TECHNICAL BULLETIN

Product : System 21 - Nexus control panels manufactured from 28th March 2005

Subject : Possible nuisance 'PS3 - out of service' faults occurring

OLDER NEXUS DESIGN

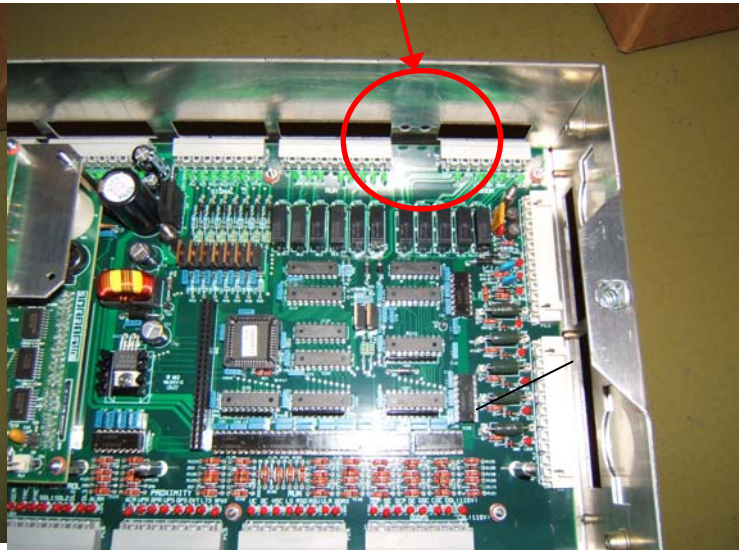
Action to be taken :

None

NEWER 'MULTILAYER' NEXUS DESIGN

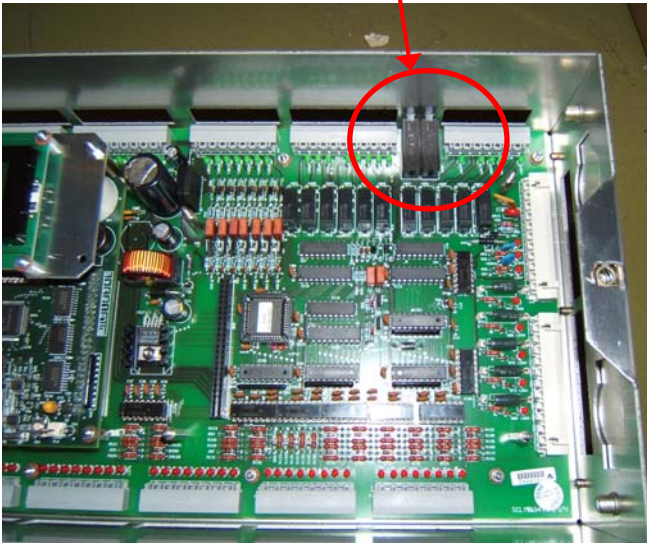
An error has occurred on wiring diagrams related to the new 'multilayer' Nexus main I/O pcbs. The outcome is that a zener diode was wired onto control panels unnecessarily. This addition *may* cause nuisance tripping of the lift putting it out of service.

On the earlier Nexus design, a zener diode was placed between S+ terminal and the 'S+ sense' input on the Nexus. When the Nexus I/O was later modified, the zener diode was brought onto the PCB but was not changed on the circuit diagram. Hence 2 zeners were effectively in series in the circuit.

The condition that may occur on site is that when the S+ 12v circuit reduces by a small amount, the lift will record the fault as 'PS3' putting the lift out of service.

To avoid the possibility of 'nuisance' tripping of the lift, the 2V7 zener found soldered onto the group panel should be replaced with a shorting wire. But only on lifts using the new Nexus 'multi layer' main I/O board as identified on the following page ;

If a zener diode is fitted to the control panel between S+ sense terminal on Nexus and the S+ terminal on the din rail then cut the white wire as it connects to the zener from the din rail, strip the end and wire it into the S+ sense terminal on Nexus.

Value = 2V7
 Component ID = BZX85C
 Stannah Part No. = 913087
 Description = Orange with Black band
